SUFFOLK COUNTY PLANNING COMMISSION

Notice of Meeting

STAFF REPORT
SECTIONS A14-14 THRU A14-25 OF THE SUFFOLK COUNTY ADMINISTRATIVE CODE

Applicant: BK Elwood LLC (The Seasons)
Municipality: Huntington
Location: w/s/o Elwood Road ~ 1200' n/o Cuba Hill Road

Z-1: BK Elwood LLC (The Seasons)
 SCPD: HU-14-01
 SCTM No: 0600-137.00-01.00-032.001

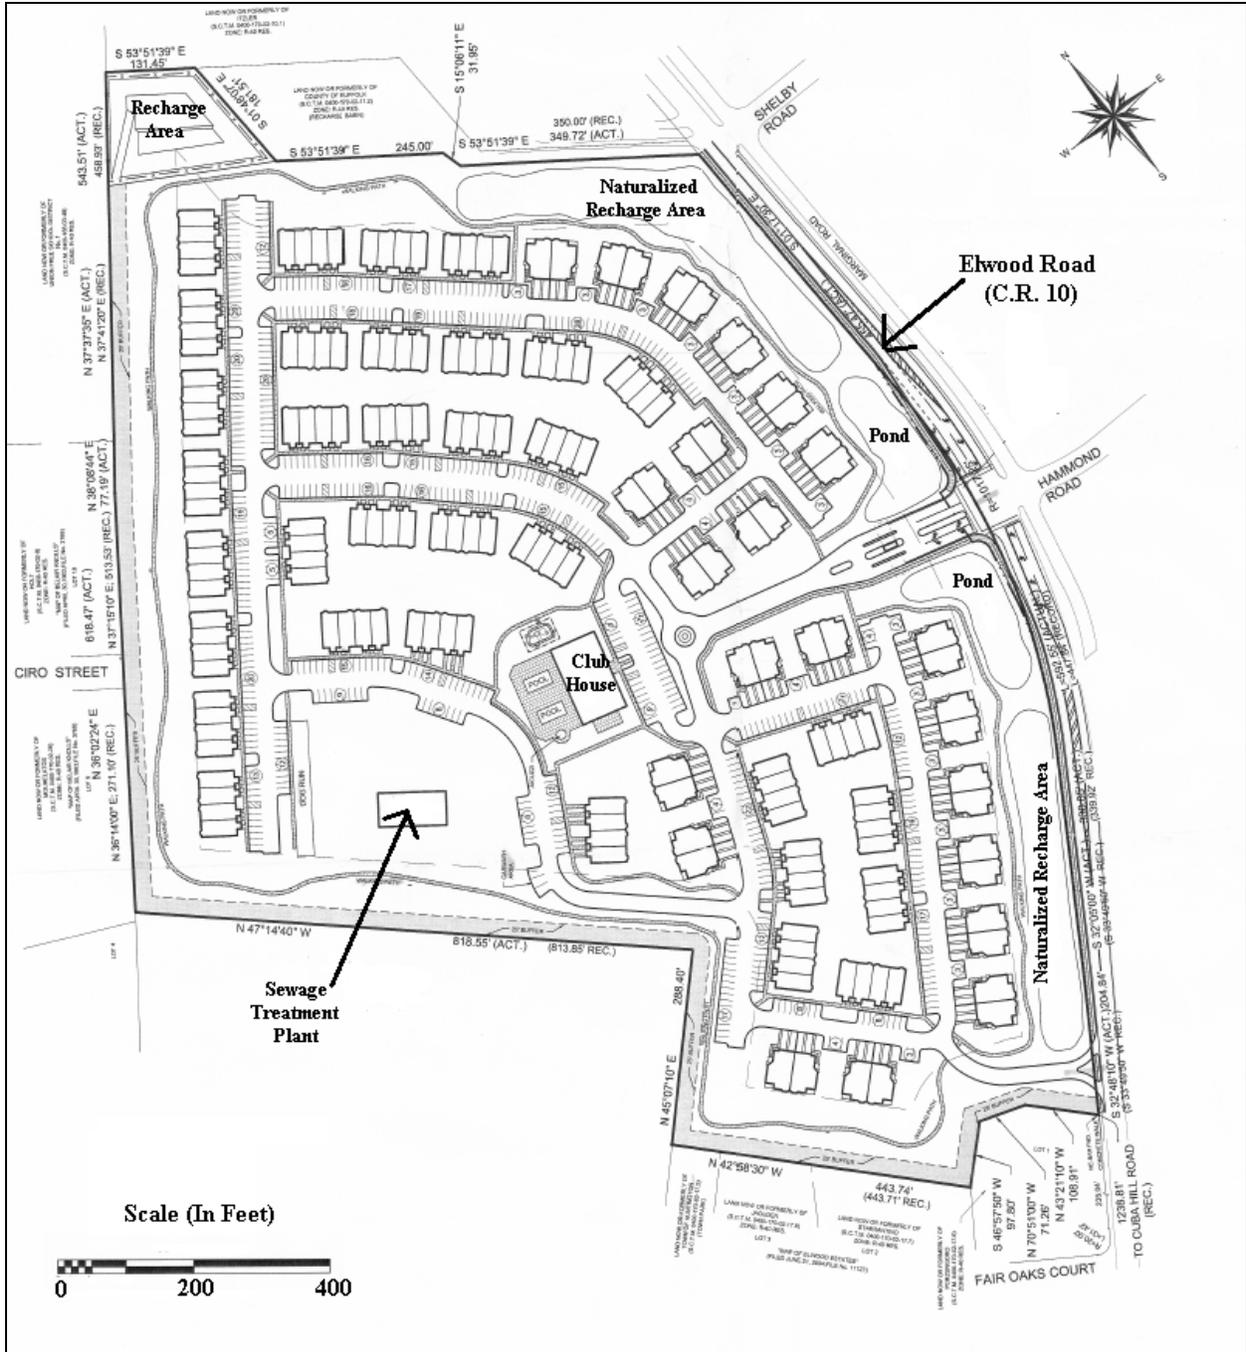
Approval of the change of zone from R-40 to R-RM for BK Elwood LLC (The Seasons) for the construction of a 360 unit age restricted senior citizen retirement community with the following modification and comments:

1. The petitioner should be required, as a condition of approval, to provide frequent and convenient transportation to the various mass transit (bus/train) drop off/pick up locations (bus stops and train stations), to the major medical/health facilities in the area, and to commercial centers where groceries and household items may be procured and entertainment may be found.

1. Early review by the Suffolk County Department of Health Services and the Suffolk County Department of Public Works is warranted and the petitioner should be directed to contact and begin dialogue with the SCDHS and the SCDPW as early as possible.

2. The petitioner should be encouraged to review the Suffolk County Planning Commission publication on The Study of man-made Ponds in Suffolk County NY and incorporate into the proposal, where practical, design elements contained therein.

3. The petitioner should be encouraged to review the Suffolk County Planning Commission publication on Managing Stormwater-Natural Vegetation and Green Methodologies and incorporate into the proposal, where practical, design elements contained therein.

4. The petitioners should be directed to contact the NYS DOT and SCDPW to resolve access and traffic considerations for ingress/egress to CR 10.
5. The petitioner should be encouraged to review the Suffolk County Planning Commission Guidebook particularly with respect to energy efficiency and incorporate where practical, applicable elements contained therein.

6. The petitioner should review the Planning Commission guidelines particularly related to public safety and incorporate into the proposal, where practical, design elements contained therein.

7. The petitioner should review the Planning Commission guidelines particularly related to universal design and incorporate into the proposal, where practical, design elements contained therein.

8. A pedestrian connection should be made between the walking path circumnavigating the proposed senior citizen development with the Huntington Town Elwood Park.
9. The Town Board may wish to consider reducing the overall density of the petition to be more in line with the recommended density from the Comprehensive Plan Update.
10. The Town may wish to cluster the overall development to the east to provide continuous recreational open space with the Town Park to the south and the School Athletic Fields to the northwest.

Z-3: S Power – Richwood Greenwood, LLC
 SCPD: RH-14-03
 SCTM No: 0600-137.00-01.00-032.001

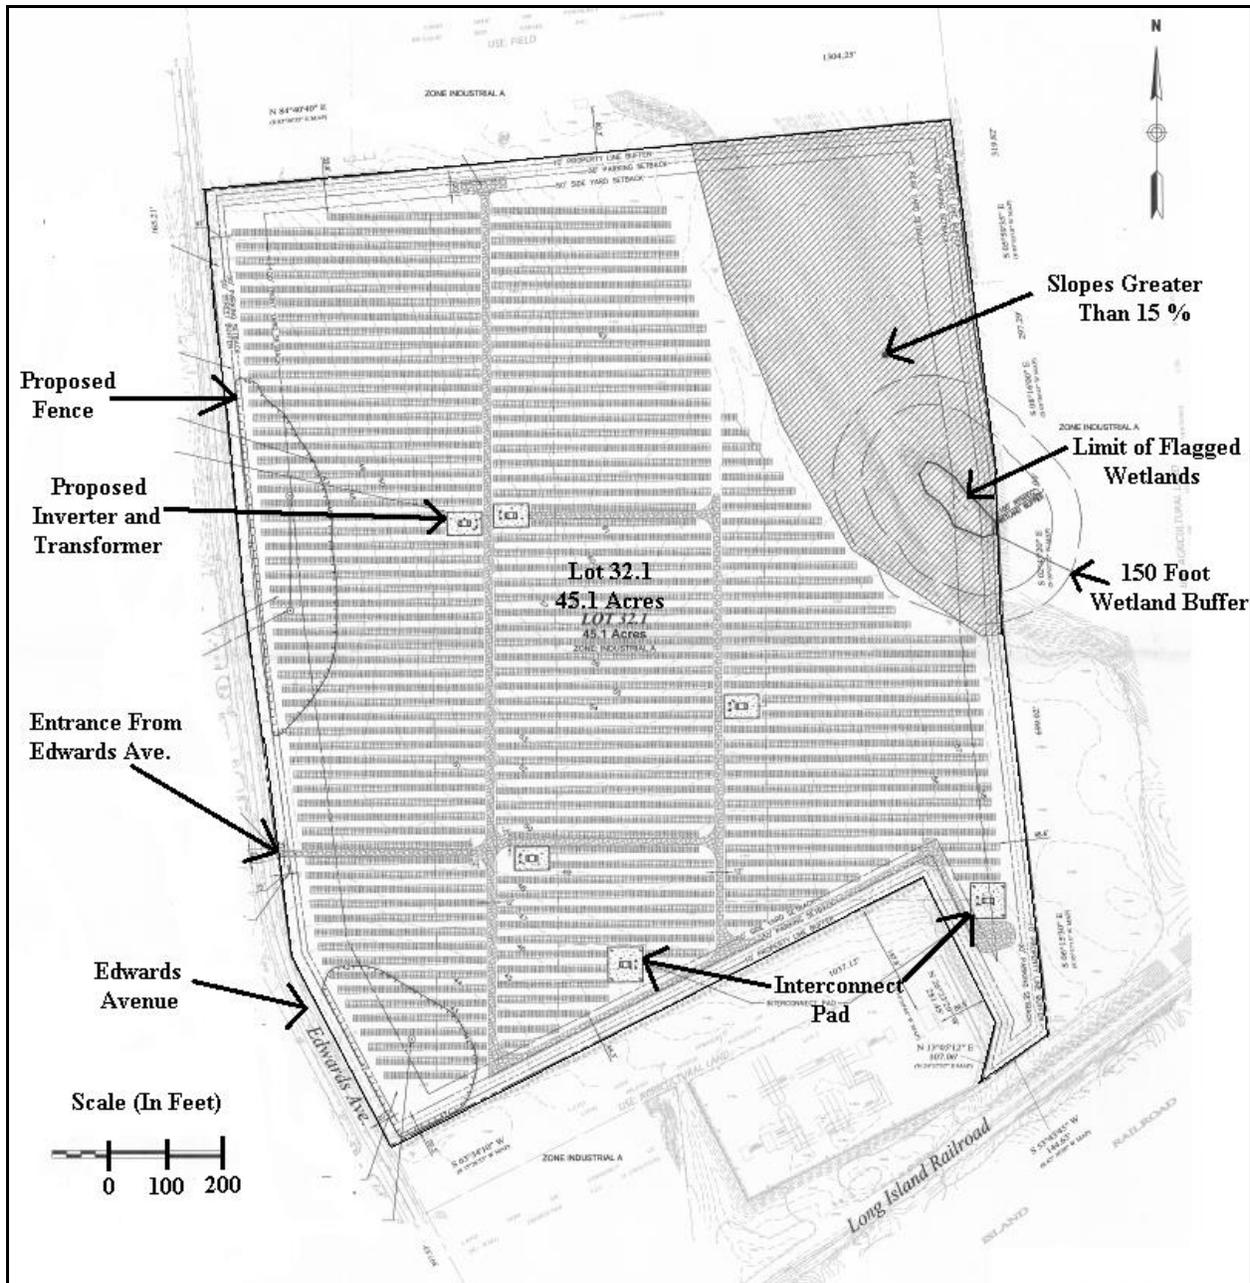
Approval of the Site Plan referral from the Town Planning Board and **Approval** of the Area Variance referral from the Town Zoning Board of Appeals, subject to the following comments:

1. The Suffolk County Planning Commission's publication on Managing Stormwater - Natural Vegetation and Green Methodologies should be reviewed and additional stormwater mitigations incorporated where practical.
2. The Town should require that the applicant be prohibited from exporting any soil material, classified as prime agricultural soils, off the subject parcel. And that the proposed solar panel arrays not negatively impact the viability of the prime agricultural soils on-site.
3. The proposed action should only be approved in such a manner that is in accordance with the New York Agriculture & Market's Law.
